Access Compliance Report

Public Rights-of-Way

Intersection ID: 47579	Main Street: EVANTON_LOCH_RD	Cross Street: BARRANDS_LN	Location: SE
ADA ID: F52CFFF782C6	Ramp Type: PerpDiag	Initial Pass/Fail: Fail	Overall Compliance: No
		Severity Score: 8.75

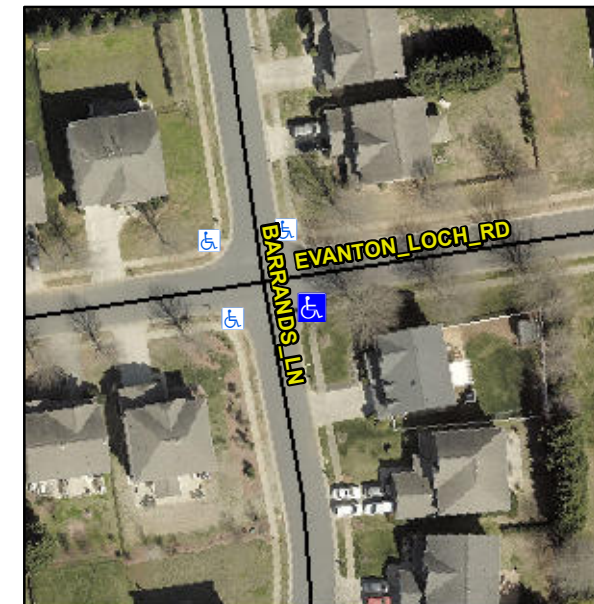
Not Found, R304.5.1

Compliance	Description	Data	Compliance	Description	Data
N/A	Ramp Length (in)	46.5	Yes	Ramp Slope (%)	7.4
No	Ramp Width (in)	45.5	Yes	Ramp XSlope (%)	1.6
N/A	Flare Type LT	N/A	N/A	Flare Type RT	N/A
N/A	Flare Slope LT (%)	N/A	N/A	Flare Slope RT (%)	N/A
N/A	Flare Traversable LT?	N/A	N/A	Flare Traversable RT?	N/A
N/A	Landing Length (in)	N/A	N/A	DWS Provided?	N/A
N/A	Landing Width (in)	N/A	N/A	DWS Contrast?	N/A
N/A	Landing Slope (%)	N/A	N/A	DWS Length (in)	N/A
N/A	Landing X Slope (%)	N/A	N/A	DWS Full Width?	N/A
N/A	Landing Curb? (Y/N)	N/A	N/A	DWS Offset (in)	N/A
N/A	Shared Landing?	N/A			
N/A	Gutter Ponding?	N/A	N/A	Gutter Slope (%)	N/A
N/A	Gutter Lip Ht (in)	N/A	N/A	Gutter X Slope (%)	N/A
N/A	Painted X Walk1?	No	N/A	Painted X Walk2?	No
	X Walk 1 Direction	To N		X Walk 2 Direction	To W
N/A	X Walk 1 Width (in)	N/A	N/A	X Walk 2 Width (in)	N/A
	X Walk 1 Slope (%)	0.2		X Walk 2 Slope (%)	3.2
	X Walk 1 X Slope (%)	2.6		X Walk 2 X Slope (%)	1.0

Remove & Replace Curb Ramp With Two New Directional Ramps or Equivalent.
